MARCH 3 1978

Docket No. 50-219

The Commission has issued the enclosed Amendment No. 29 to Provisional Operating License No. DPR-16 for the Oyster Creek Nuclear Generating Station. The amendment consists of changes to the license and is in partial response to your application dated September 30, 1977 and your letters dated December 3, 1976, August 11, 1977 and October 3, 1977.

FIGURE 6.2.1
 OYSTER CREEK STATION
 MANAGEMENT ORGANIZATION CHART

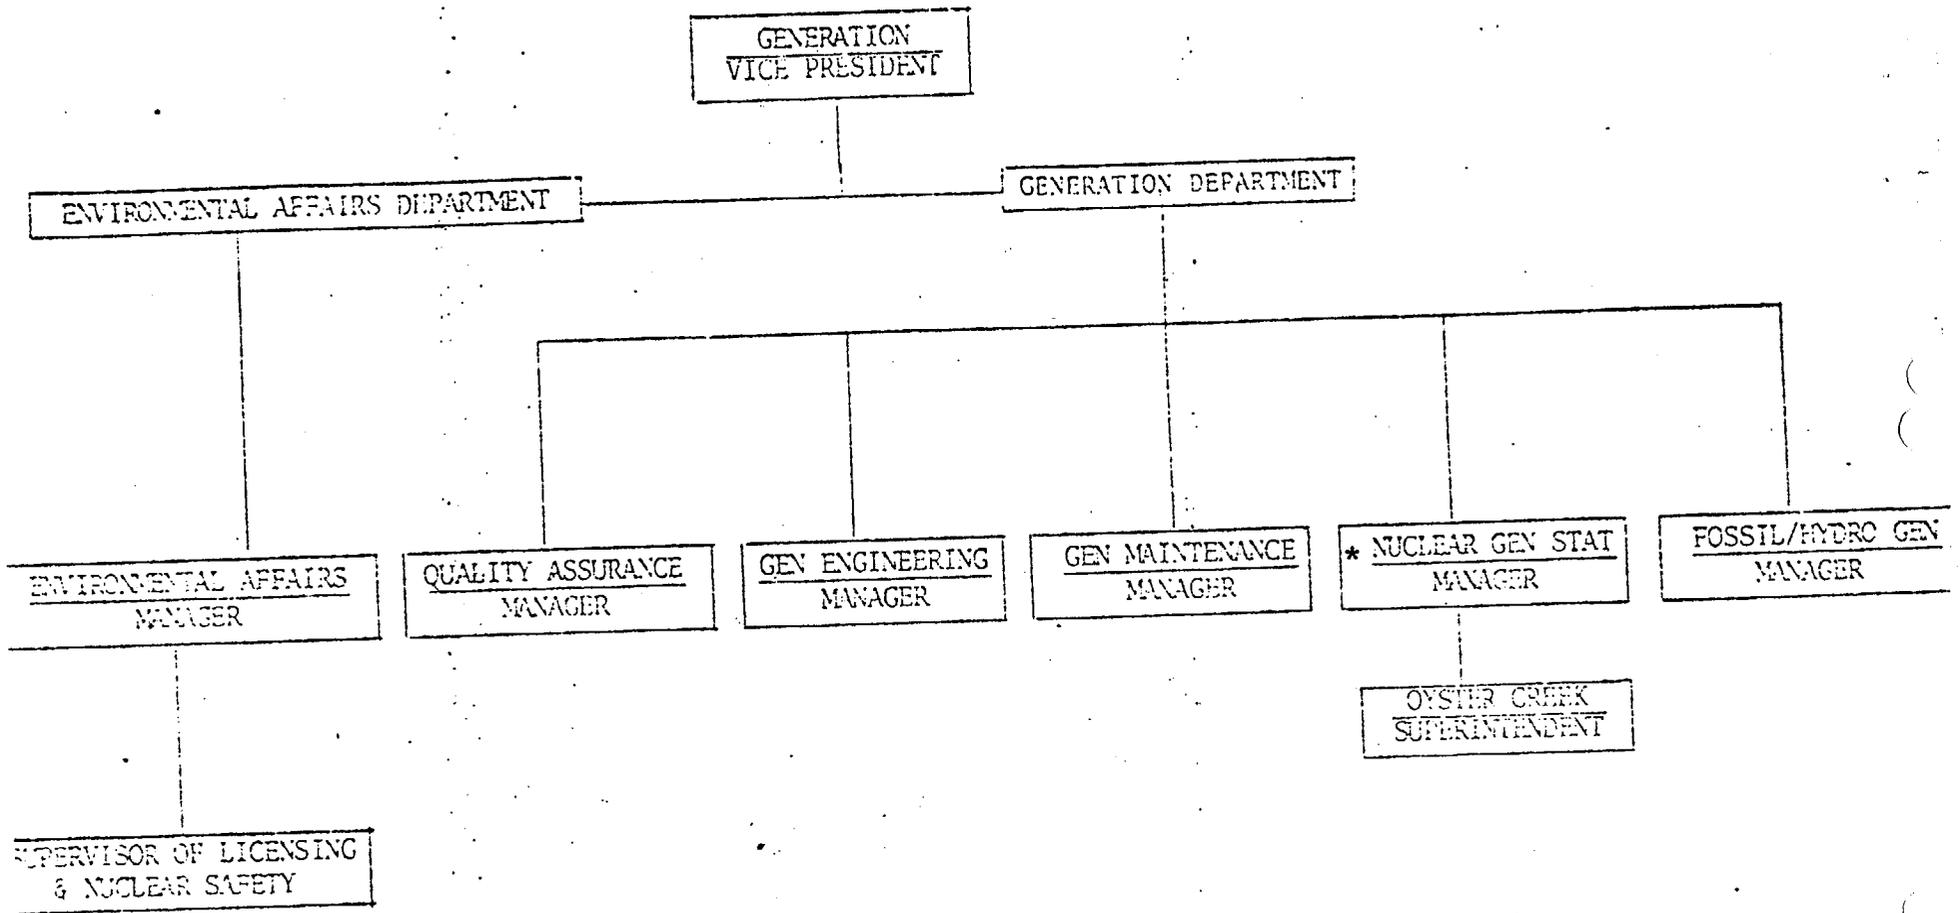
- 6.2.1 The offsite organization for facility management and technical support shall be as shown on Figure 6.2.1.

FIGURE 6.2.2
OYSTER CREEK STATION
CONDUCT OF
OPERATIONS CHART

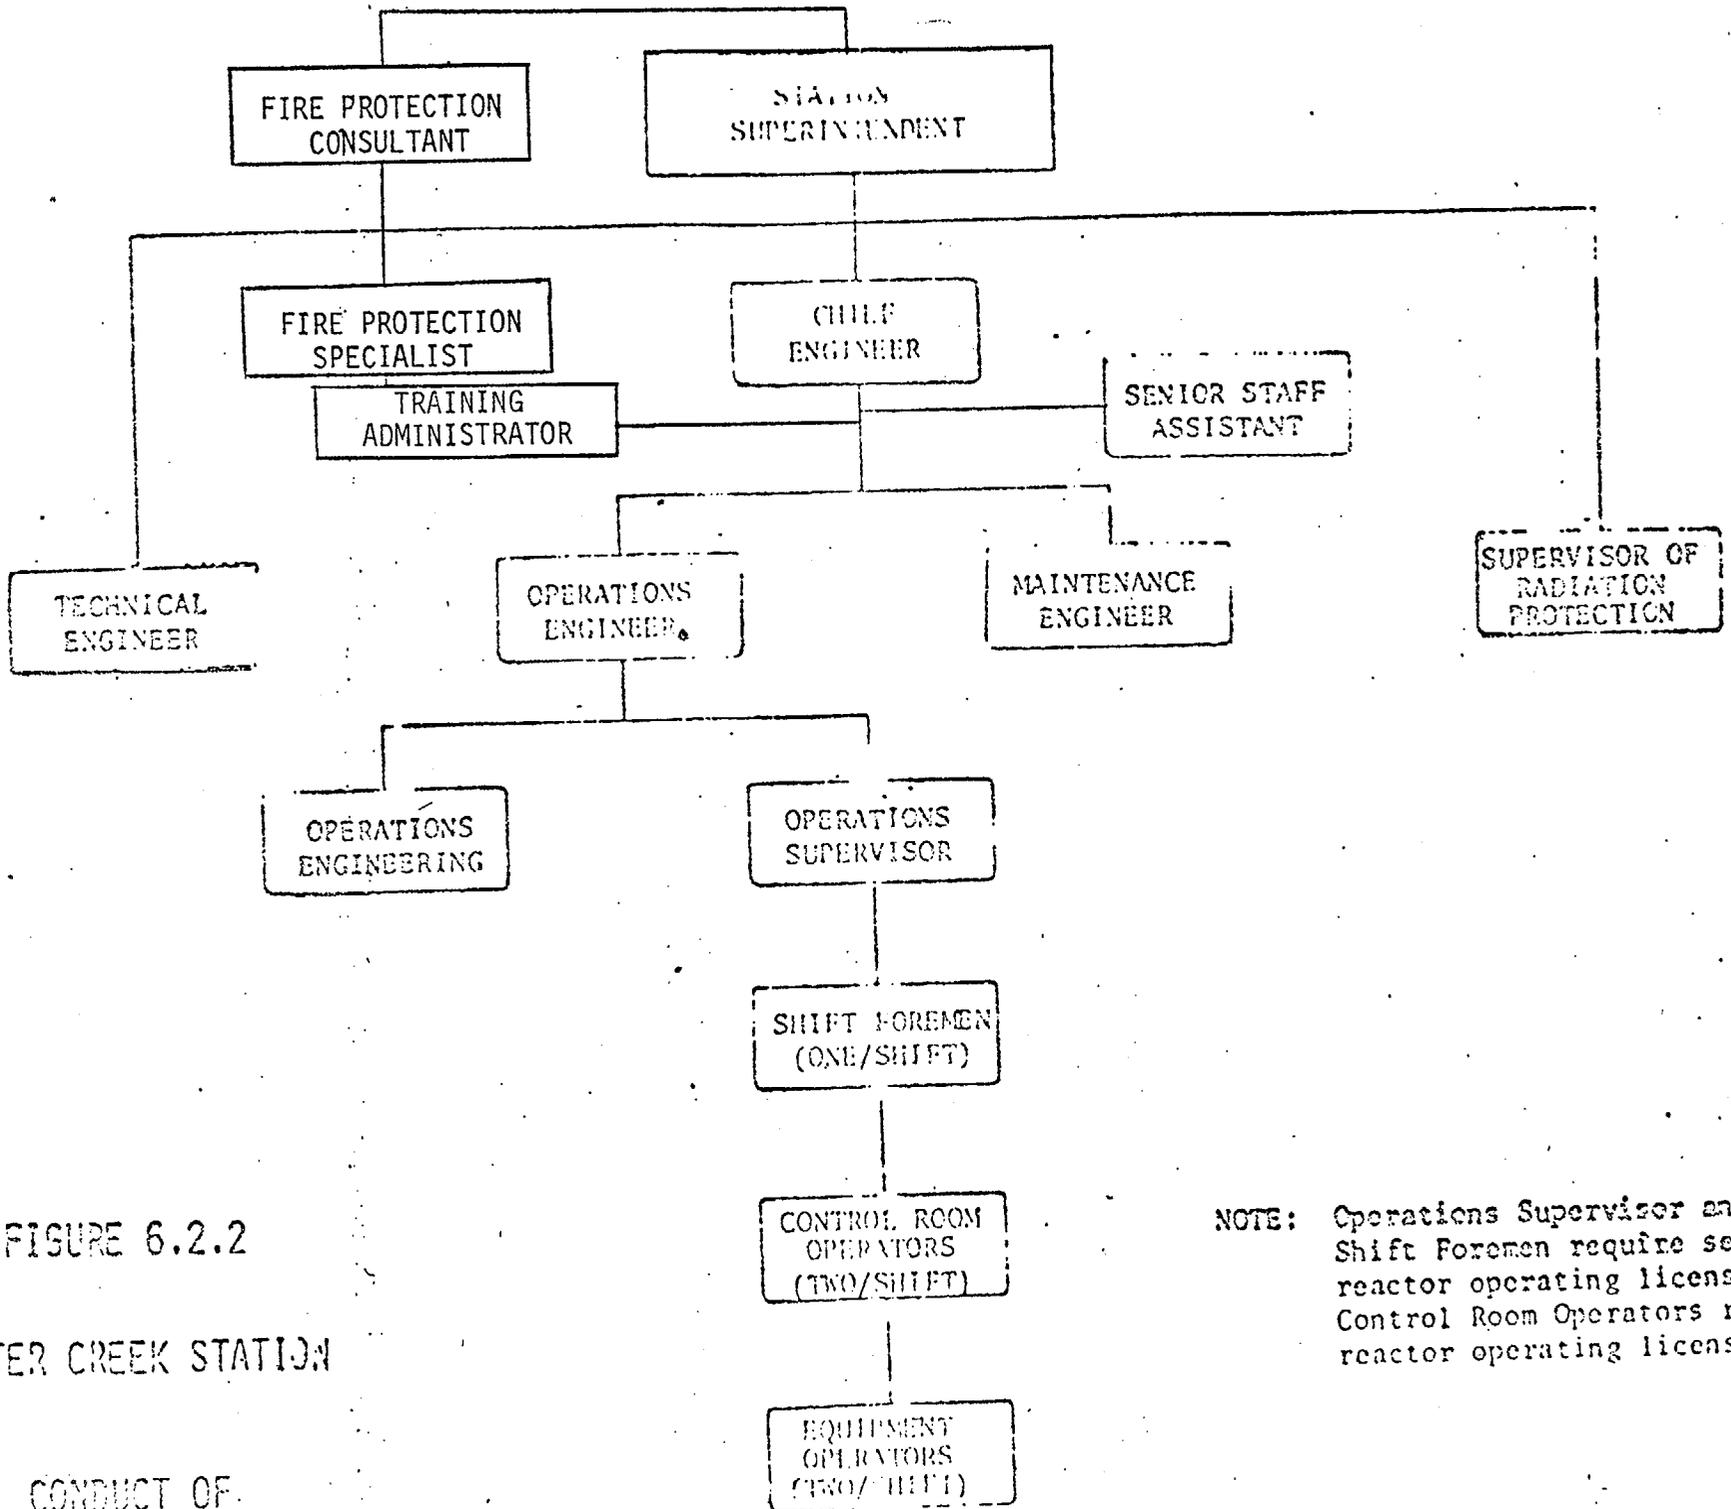
- 6.2.2 The facility organization shall be as shown on Figure 6.2.2 and:

- a. Each on duty shift shall include at least the shift staffing indicated on Figure 6.2.2.
- b. At least one licensed operator shall be in the control room when fuel is in the reactor.
